Immingham Green Energy Terminal

10.8 Proposed Further Change Application Report

Document Reference: TR030008/EXAM/10.8

FURTHER CHANGE
APPLICATION REPORT -
STOPPING UP AND RESTRICTION OF USE OF
STREETS AND PUBLIC RIGHTS OF WAY PLAN
CHANGES FOR PROPOSED CHANGES 5 - 9
SHEET 1 OF 2

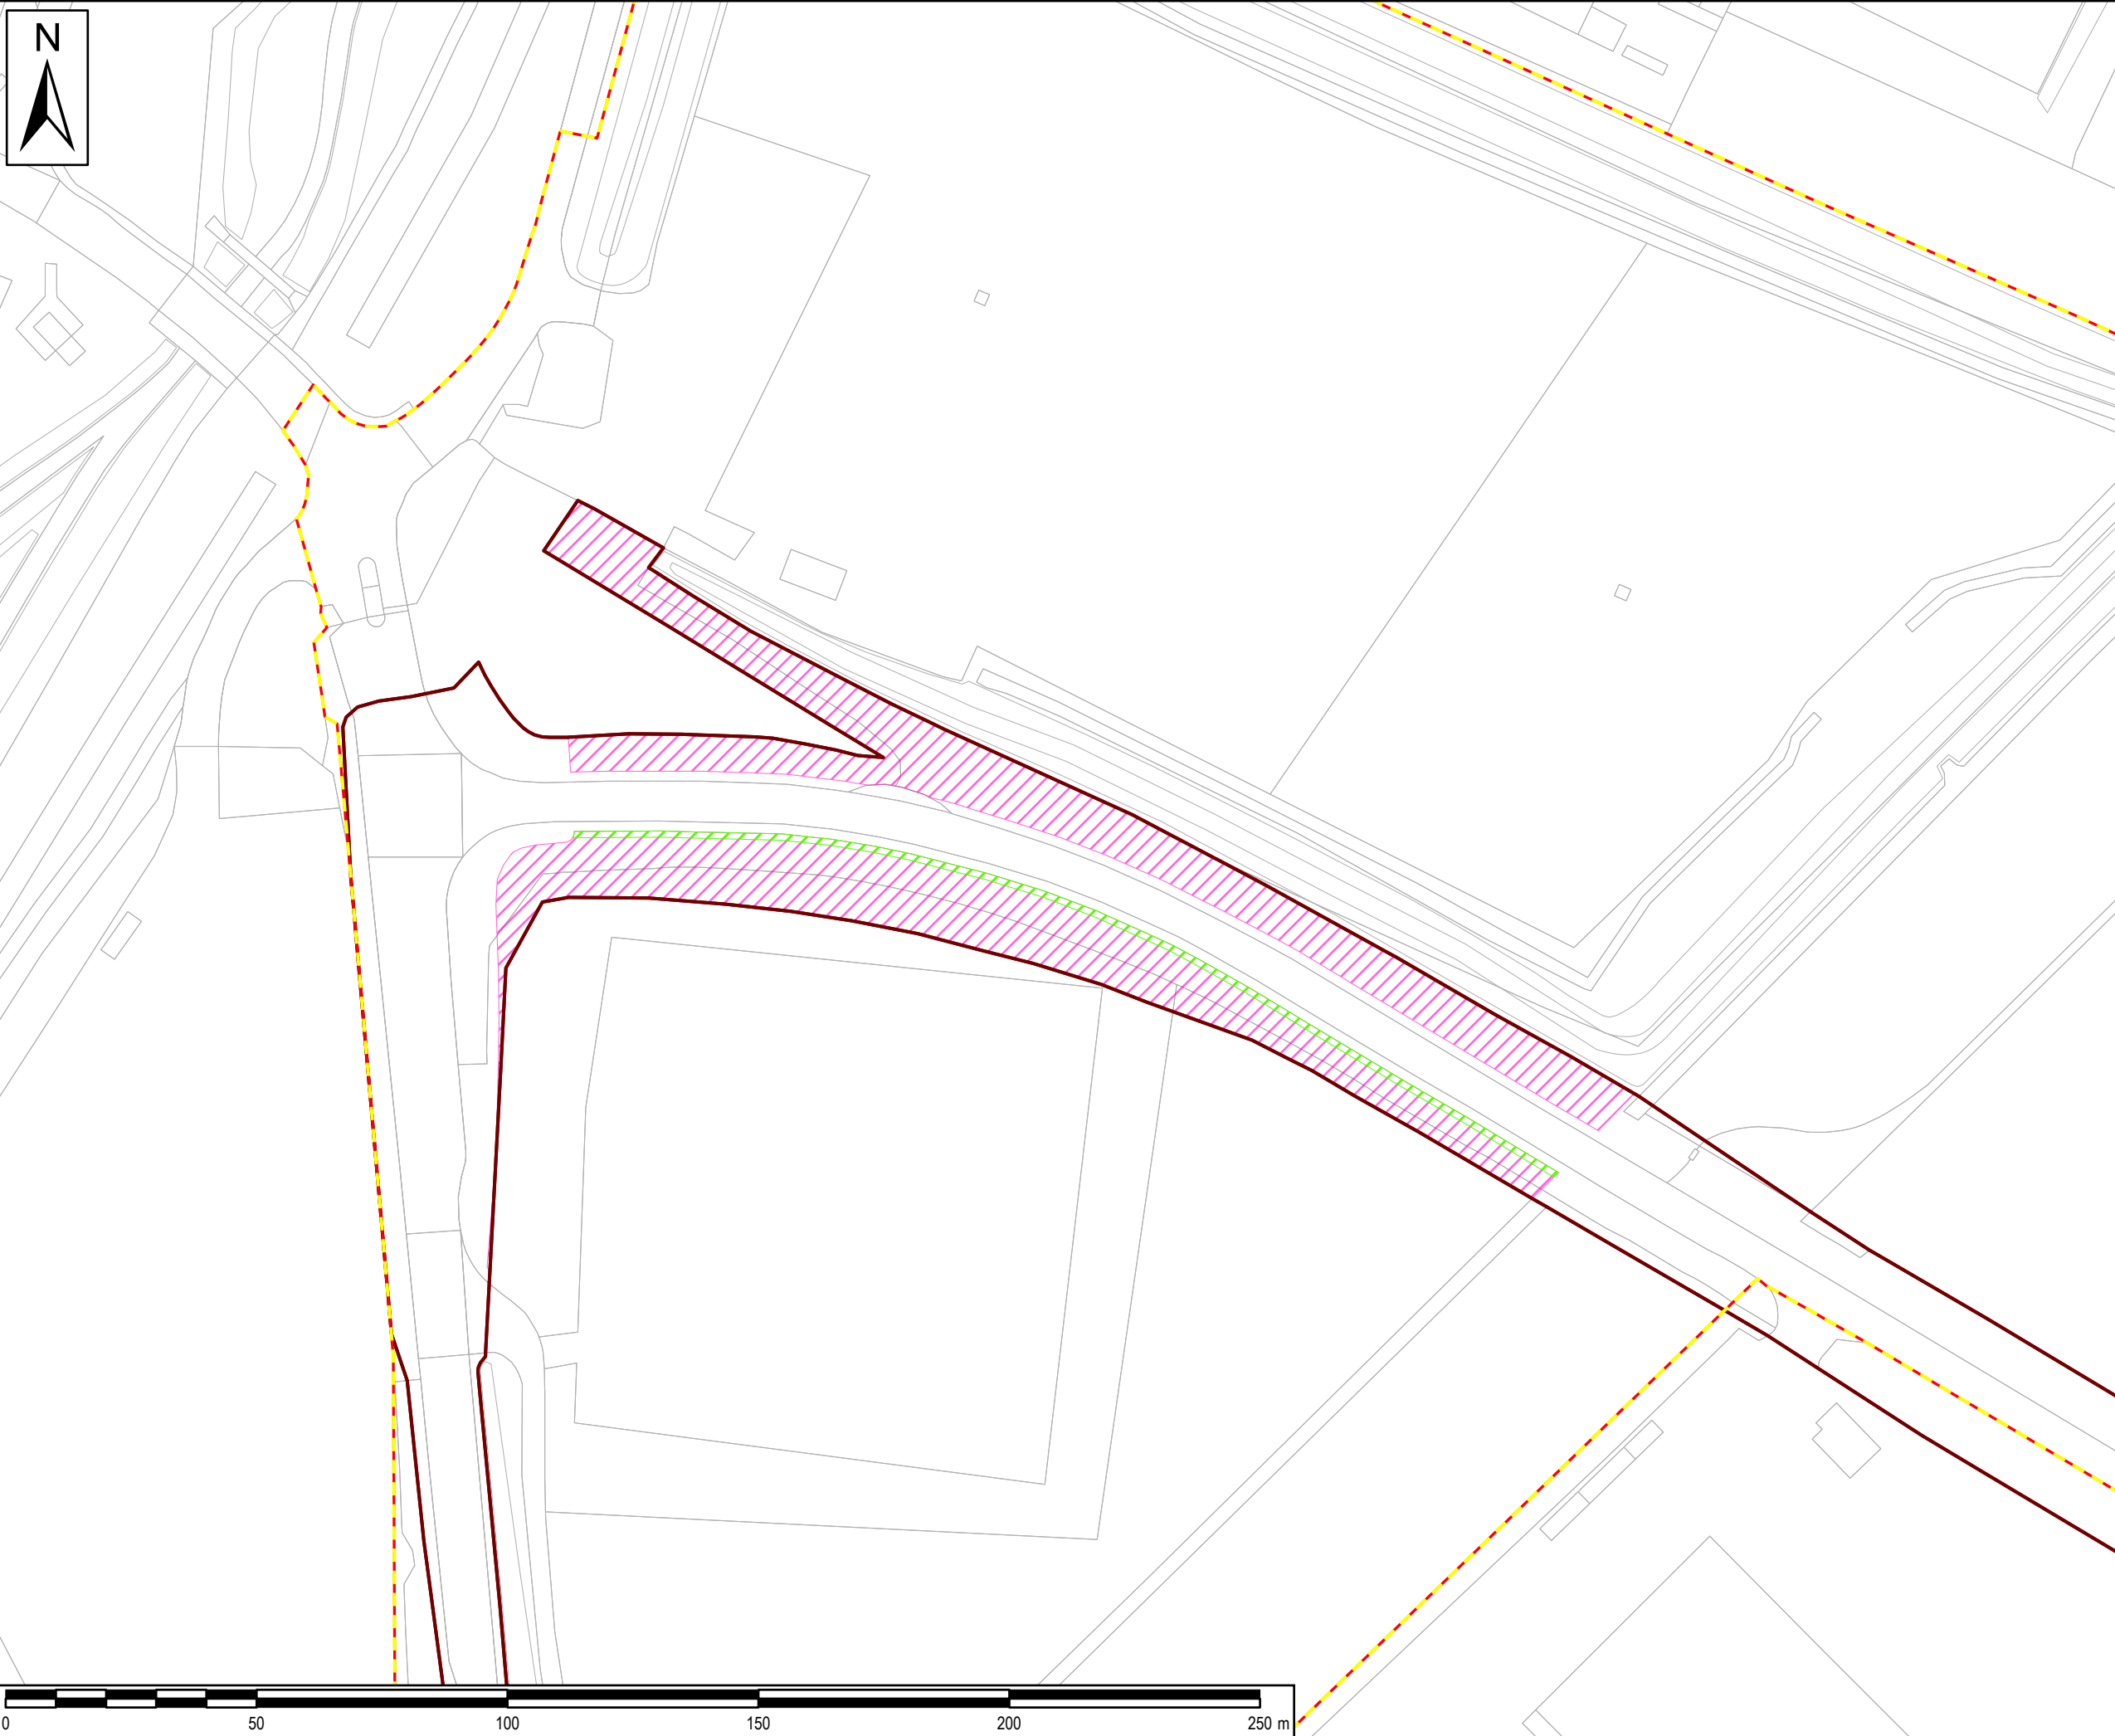
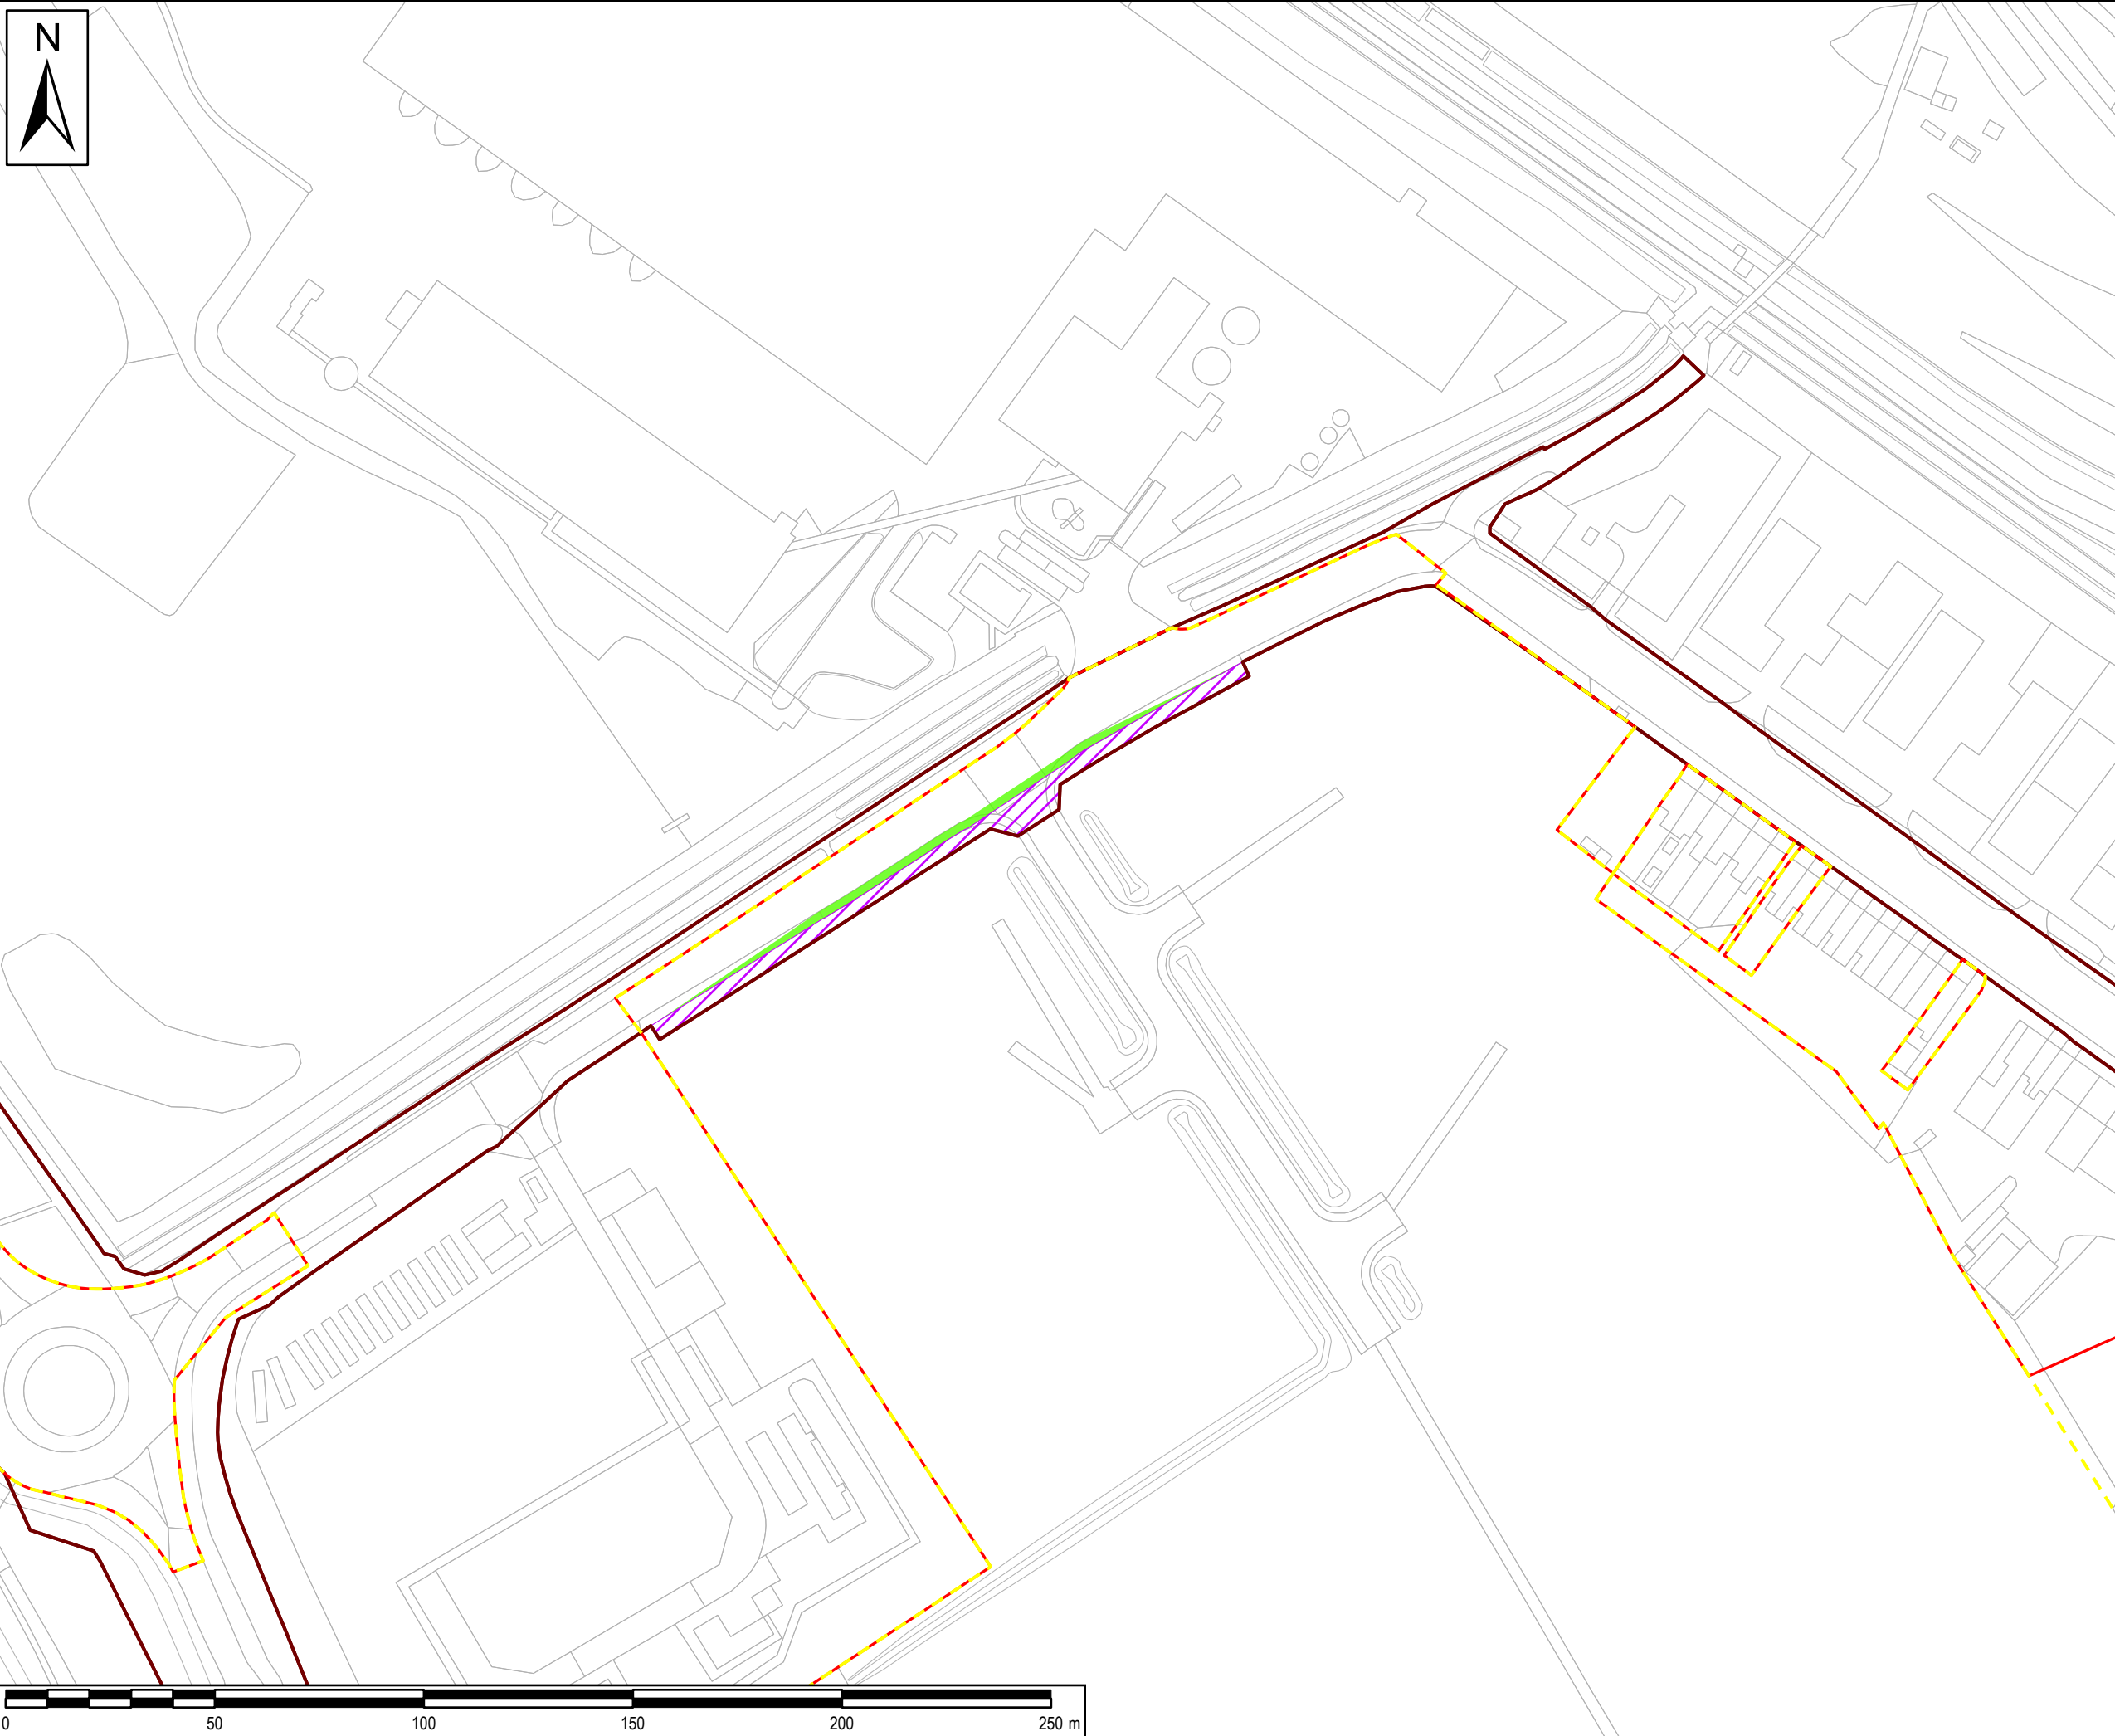
- 2.2 Proposed Change 5(a): minor changes to accesses from A1173 to Work No. 7
- 2.2.1 Proposed Change 5(a) comprises minor adjustments to the two accesses from the A1173 to Work No.7 (Access AB and Access AC as shown on the **Street Works and Accesses Plan [TR030008/APP/4.6(3)]**). **Appendix 1** identifies the location of this proposed change and **Appendix 3** illustrates the details of the proposed change.

proposals and, as a result, minor adjustments to the final shape of the polygons for Access AB and Access AC (from those shown on the indicative plans contained in the PFCNR) have been made. These adjustments (resulting in slightly larger polygons) are to provide more flexibility at the detailed design stage so as to ensure that the final design of the access and consequential alignment changes to the cycleway can be accommodated. The minor nature and scale of these adjustments do not result in any change to the assessments contained in the PFCNR. **Appendix 2** has been updated (from that contained in the PFCNR) to show the final proposed polygons. The **Street Works and Accesses Plan [TR030008/APP/4.6(3)]** and the **Stopping Up and Restriction of Use of Streets and Public Rights of Way Plan [TR030008/APP/4.7(3)]** contain the final proposed polygons.

- 2.3.2 **Appendix 1** identifies the location of this proposed change and **Appendix 3** illustrates the details of the proposed change.
 - 2.3.3 The need for this change results from engagement with NELC Highways on the detailed design of the retained verges and visibility splays. As a result, there would be a minor (beneficial) reduction of the extent of Work No. 3 of approximately 19.45 m² to exclude the area that would remain public highway and adjust the Work No. 3 boundary accordingly.

NELC Highways. As a result, there would be a minor (beneficial) reduction in Work No. 7. **Appendix 1** illustrates the location of the proposed change and **Appendix 3** illustrates the proposed area of stopping up.

2.5.4 The implementation of this Proposed Change 6 would involve updates to the **Stopping Up and Restriction of Use of Streets and Public Rights of Way (PRoW) Plan [TR030008/APP/4.7(3)]** and details of the area of permanent stopping up would be included in Schedule 6 of the **dDCO [TR030008/APP/2.1(6)]**. There would also be associated alterations to the **Works Plans [TR030008/APP/4.2(4)]** to reflect the minor reduction in Work No. 7 and to the **Land Plans [TR030008/APP/4.5(3)]** and the **Book of Reference [TR030008/APP/3.1(3)]** to identify a new plot 7/24 (previously forming part of plot 7/13) which is the proposed area of stopping up, and a slight enlargement of plot 7/12 (which is highway land) to reflect the revised highway boundary.
